10-K-22-HZ
APPLICATION FOR CERTIFICATE OF APPROPRIATENESS

1017 Thompson Place 37917
Old North Knoxville H

Staff Report

File Number: 10-K-22-HZ

FRONT ELEVATION

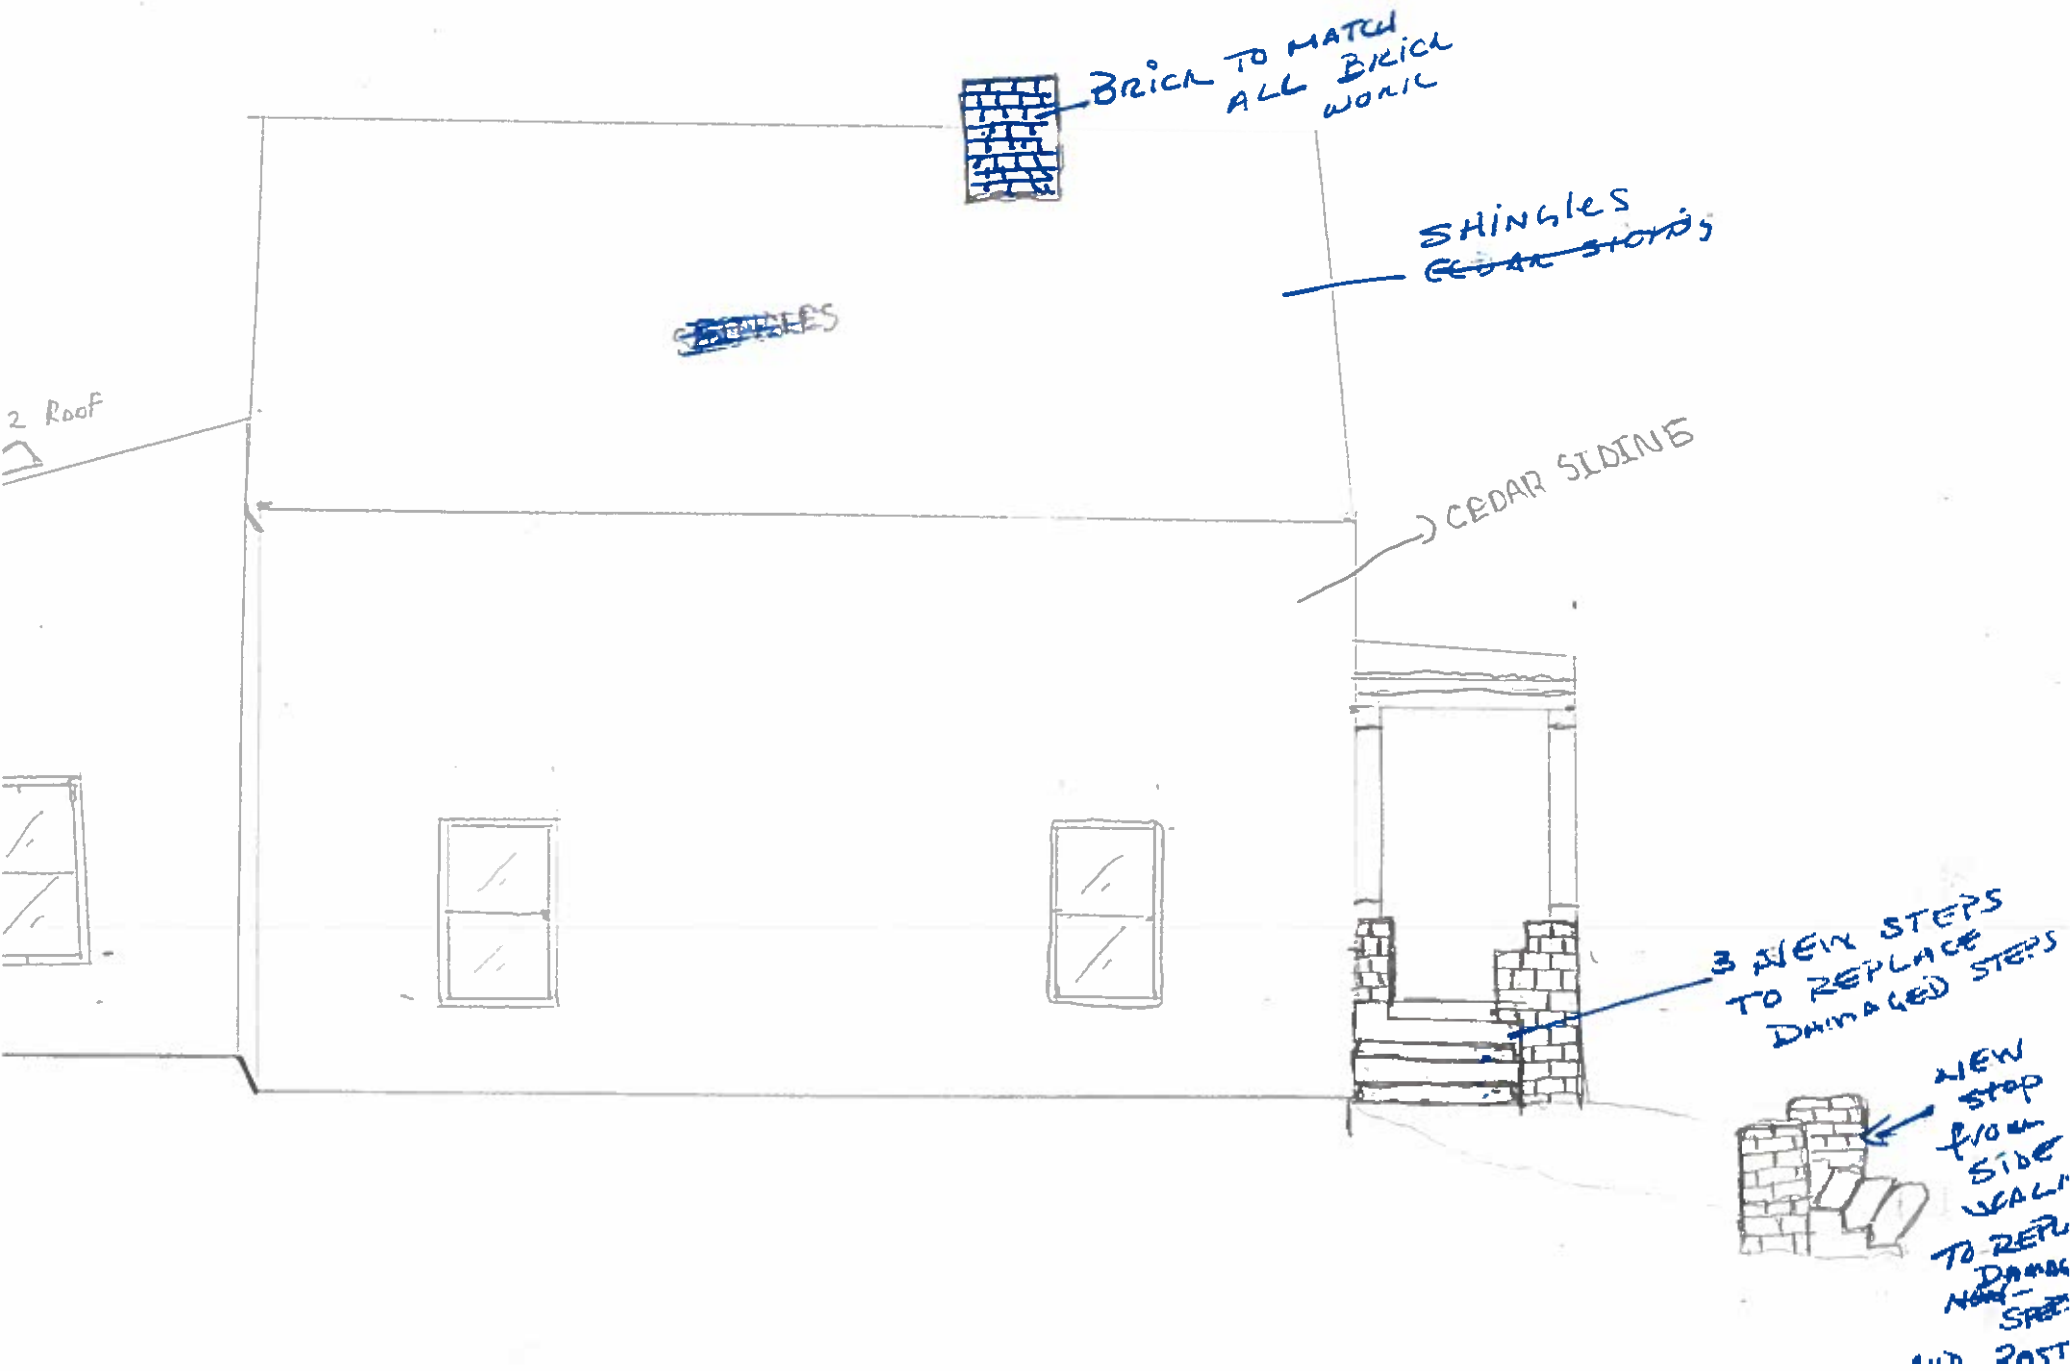
2. The secondary façade door (now removed) is not an original element of the house, most likely installed when the house was converted to multiple units. Removal of the secondary door meets the design guidelines. Associated with the removal of the second façade door, the Commission should discuss the revised placement of the façade first-story windows.

5. Design guidelines for doors note that a new entrance must be compatible in size, scale, and material, with restoration based on physical documentation. The proposed door and sidelights are a contemporary interpretation of a wood Craftsman door and window elements. Glass used in the transom, sidelights, and door should be clear and the door should avoid overly decorative staining or carving details. The Commission should discuss the proposed rear door and determine whether it is compatible with primary entrances in size, scale, and materials. Comparable doors have been approved on non-visible elevations in ONK in the past.

6. Repair to the brick porch wall should meet the design guidelines for masonry repair; any new mortar should be matched to the existing in composition and color. Reconstruction of the deteriorated paired wood porch columns is appropriate within the guidelines, provided the reconstructed columns and their bases match the originals in size and design.

- 1) Applicant to select new windows which meet the design guidelines and submit to staff for approval, along with revising the exterior window trim to reflect the original;
- 2) Chimneys to be restored to match original detailing;
- 3) Reconstructed porch columns to match originals in size and design;

And providing for Commission discussion on new front and rear doors, louvered attic vents, and revised façade window placement.

Façade and right side elevation photos taken by staff

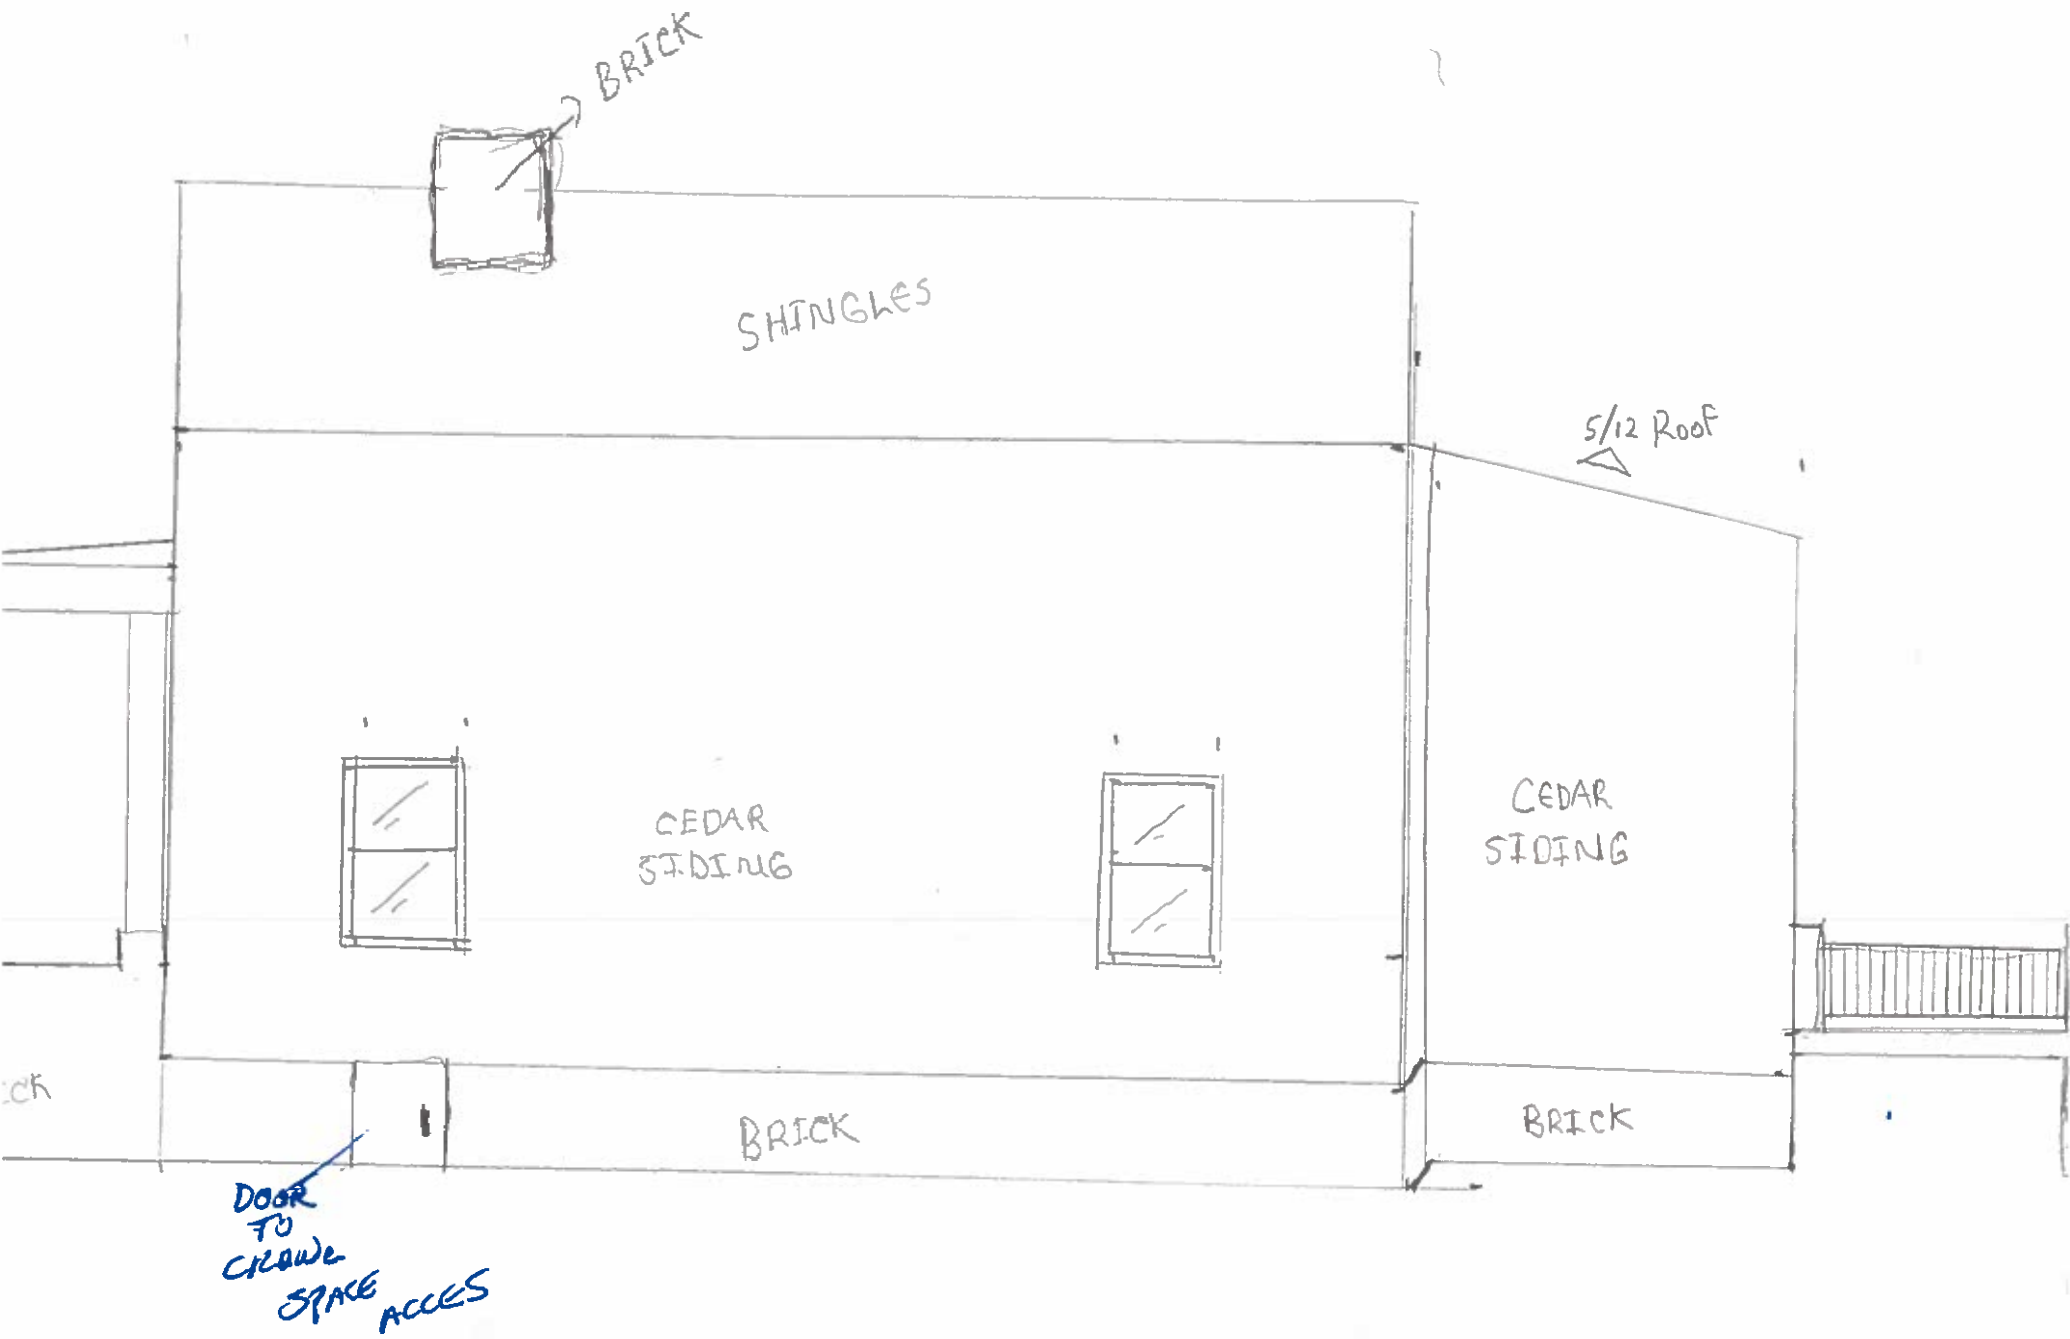
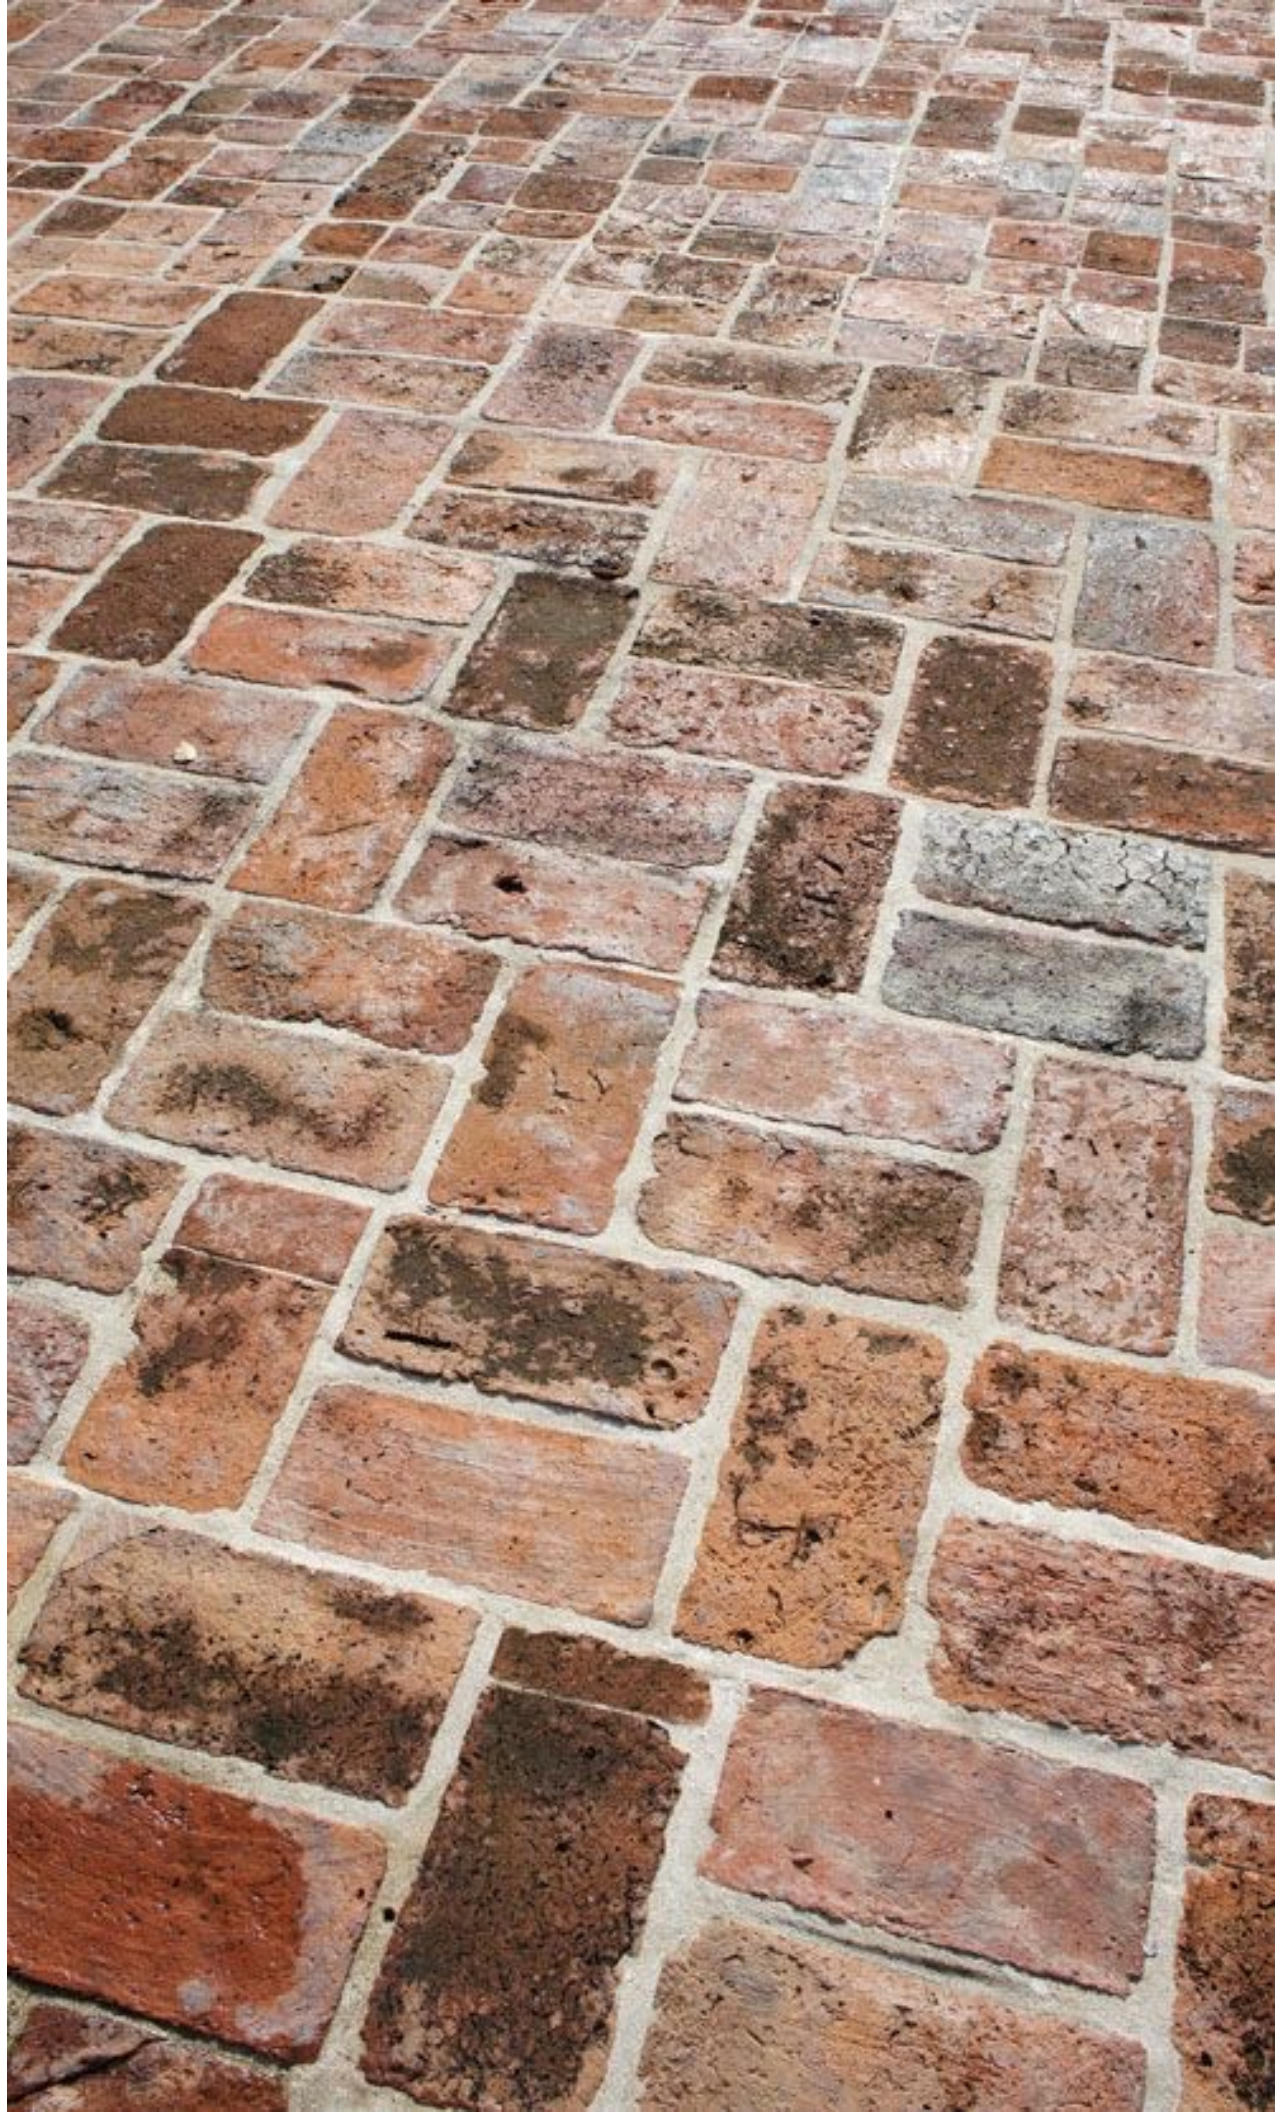
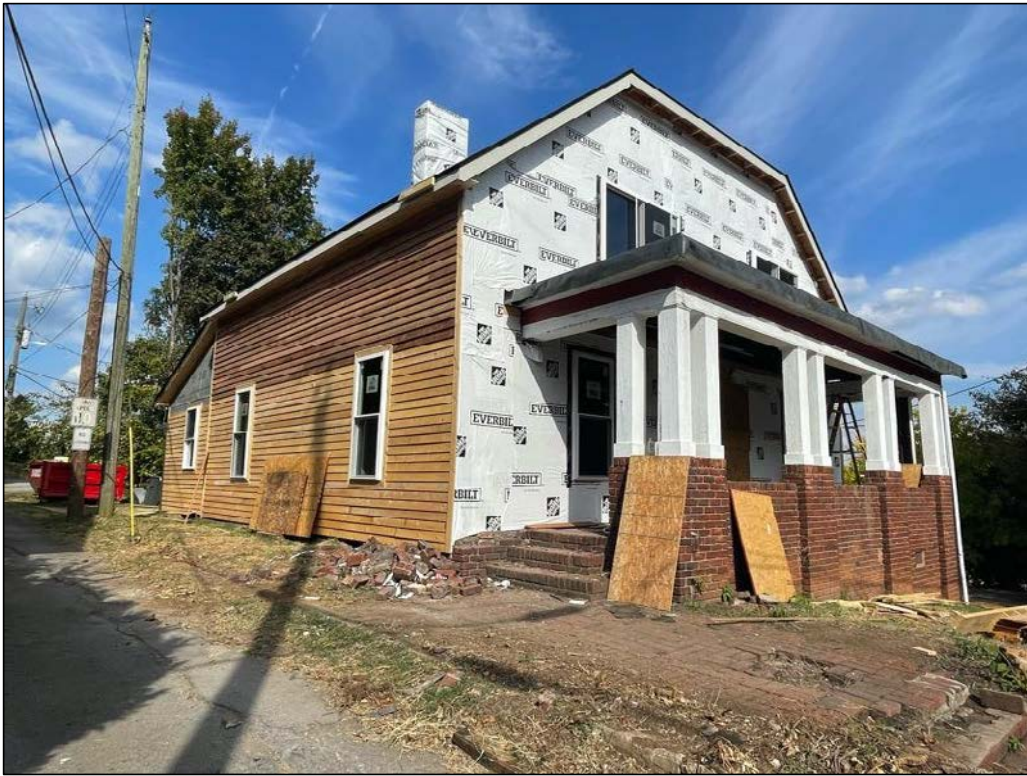
3. The proposed windows were not approved under 6-G-20-HZ or 7-G-201-HZ and do not meet the design guidelines. The original windows were two-over-two, double-hung wood windows and four-light wood casement windows. The installed windows are composite or vinyl, one-over-one windows which project slightly outward from the siding, and composite or vinyl sliding windows on the second story.

4. Guidelines recommend repairing or replacing roof details, including chimneys and attic vents. The two brick masonry chimneys were unique features, evenly spaced with one on each roof slope and featuring a simple corbelling detail at the top. Previous approvals have noted that both chimneys and the three adjoining rectangular wood louvered vents should be restored in-kind. The wood louvered vents visible on old Streetview images of the house may not be original.

Window and trim detail photo taken by staff

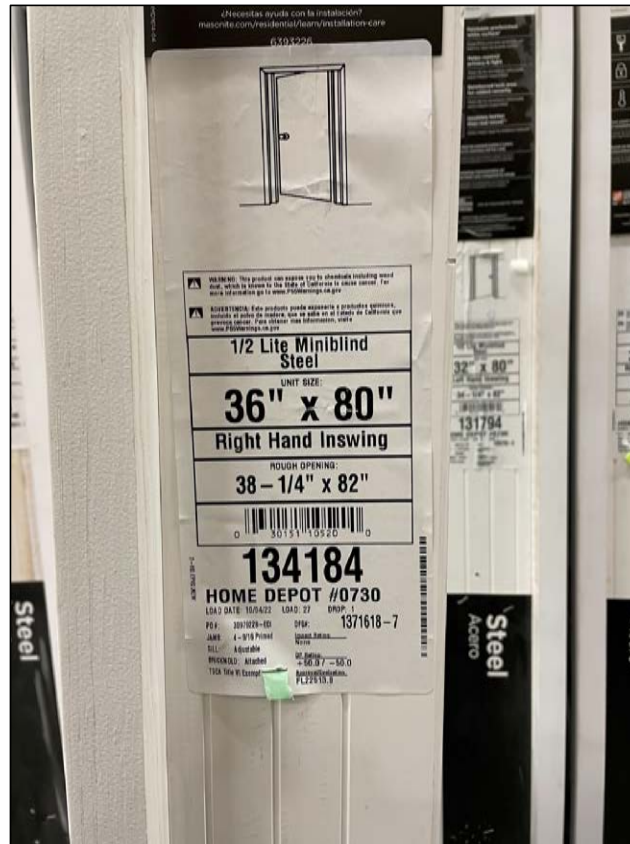
Design guidelines recommend that replacement windows be the "same overall size as the originals, with the same pane division and same muntin depth, width, and profile" and "the same materials as the original windows, which were generally wood." The applicant should select new window specifications which meet the design guidelines and submit to staff for approval. The flat window trim does not reflect the original window trim design in size or design and should be revised.
